Access Compliance Report Public Rights-of-Way (Curb Ramps)

Intersection ID: 5535 Main Street: UNIVERSITY_CITY_BV Cross Street: MARLYNN_DR Location: NE

ADA ID: 41299CAA74FE Ramp Type: Perp Initial Pass/Fail: Fail Overall Compliance: No Severity Score: 13.75

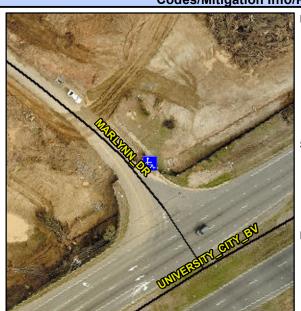
R304.2.2, R304.5.3

Field Measurements/Component Compliance					
Compliance Description		Data	Comp	liance Description	Data
N/A	Ramp Length (in)	48.0	No	Ramp Slope (%)	9.5
Yes	Ramp Width (in)	48.0	No	Ramp XSlope (%)	2.6
N/A	Flare Type LT	N/A	N/A	Flare Type RT	N/A
N/A	Flare Slope LT (%)	N/A	N/A	Flare Slope RT (%)	N/A
N/A	Flare Traversable LT?	N/A	N/A	Flare Traversable RT?	N/A
N/A	Landing Length (in)	N/A	N/A	DWS Provided?	N/A
N/A	Landing Width (in)	N/A	N/A	DWS Contrast?	N/A
N/A	Landing Slope (%)	N/A	N/A	DWS Length (in)	N/A
N/A	Landing X Slope (%)	N/A	N/A	DWS Full Width?	N/A
N/A	Landing Curb? (Y/N)	N/A	N/A	DWS Offset (in)	N/A
N/A	Shared Landing?	N/A			
N/A	Gutter Ponding?	N/A	N/A	Gutter Slope (%)	N/A
N/A	Gutter Lip Ht (in)	N/A	N/A	Gutter X Slope (%)	N/A
N/A	Painted X Walk1?	No	N/A	Painted X Walk2?	N/A
	X Walk 1 Direction	To W		X Walk 2 Direction	N/A
N/A	X Walk 1 Width (in)	N/A	N/A	X Walk 2 Width (in)	N/A
	X Walk 1 Slope (%)	3.9		X Walk 2 Slope (%)	N/A

Remove & Replace Entire Ramp.
